CITY PLANNING COMMISSION

APPLICATION: A. Negative Declaration
B. Special Permit to develop halfplex units in the R-1A-PUD zone

PROPOSAL: The applicant is requesting the necessary entitlements to develop 234 halfplex units on 117 corner lots in five subdivisions located in the LPPT PUD (aka Riverlake)

EXHIBIT D

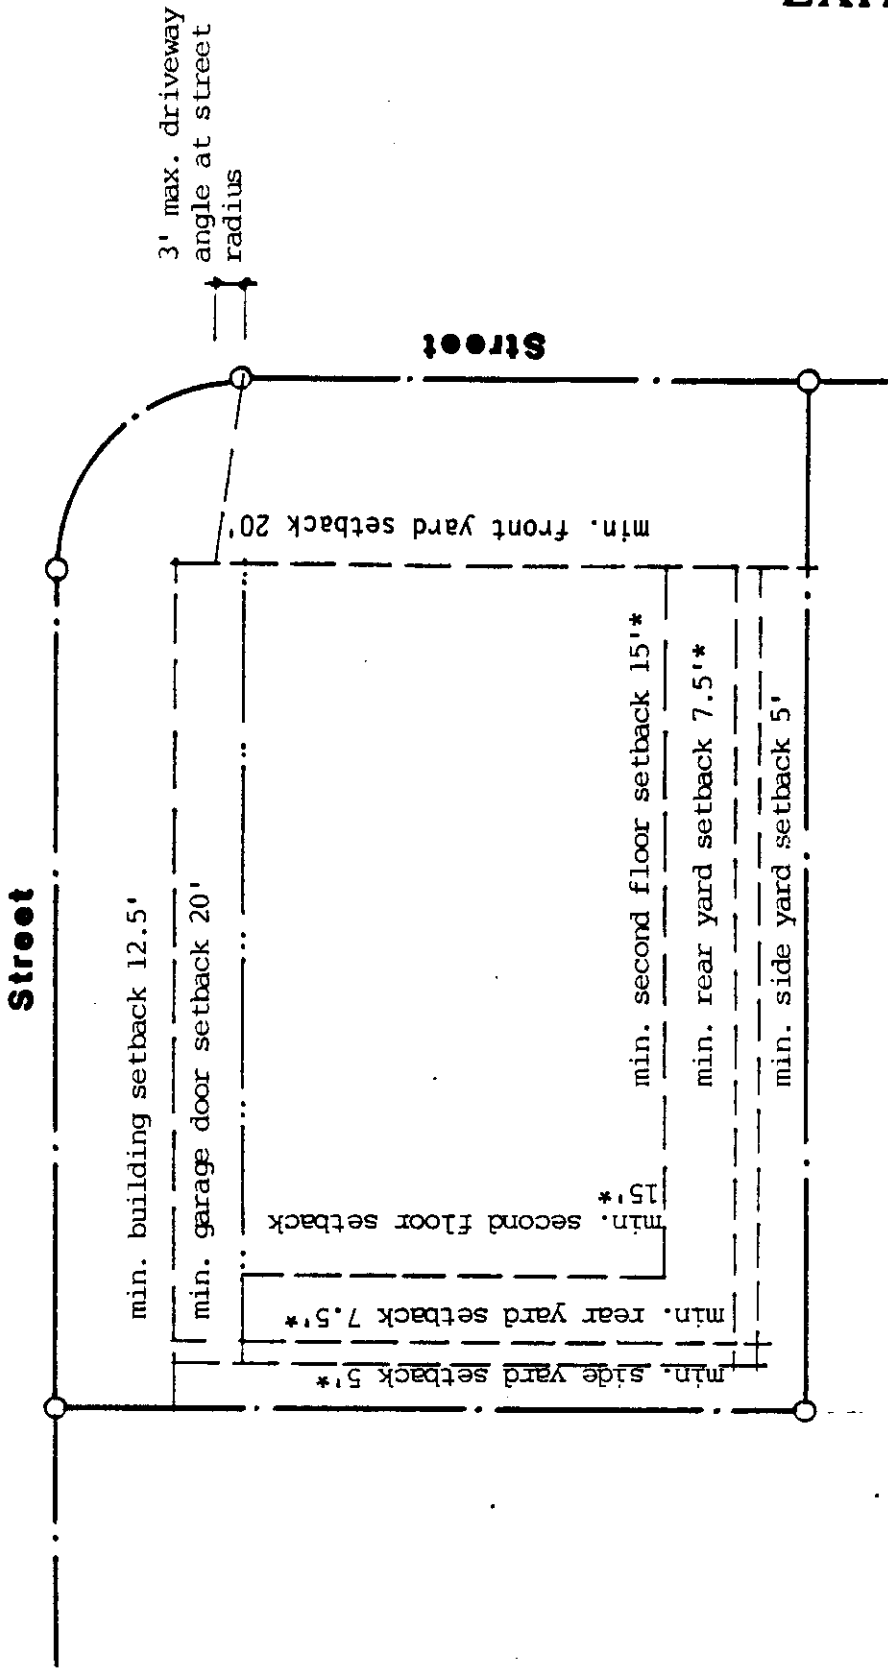
Planning Staff met with the applicant to determine minimum setback and outdoor patio area standards for the custom halfplexes. (Exhibit D). The applicant has also prepared exhibits to show how these building setbacks would work for various halfplex types. Staff finds the proposed setbacks to be appropriate for the custom halfplexes while providing for the privacy of adjacent property owners. Staff recommends that each proposed halfplex unit be subject to Planning Staff review and approval to assure that the appropriate setbacks are met and that the design and materials are compatible with adjacent single family uses.

1. Halfplex units on the 117 R-1A PUD zoned corner lots in the Dutra Bend, Cobble Shores, Riverlake Lot 4, Handover Bend and Stillwater Subdivisions of the LPPT PUD which do not meet the minimum setback requirements of the City Zoning Ordinance shall be subject to the following regulations (See also Exhibit D):

- Rear Yard: The yard area between the halfplex structure and the property line where the main indoor living space is parallel to the property line;
 - b. The minimum rear yard setback shall be 7.5 feet for the first floor and 15 feet for the second floor;

- c. The minimum side yard setback shall be 5 feet for the first and second floors;
 - d. Each halfplex unit shall maintain one outdoor patio of not less than 140 square feet (open to air) behind its minimum rear yard setback directly adjacent to its main indoor living space. The minimum depth of the outdoor living patio shall be 15 feet measured from the rear property line;
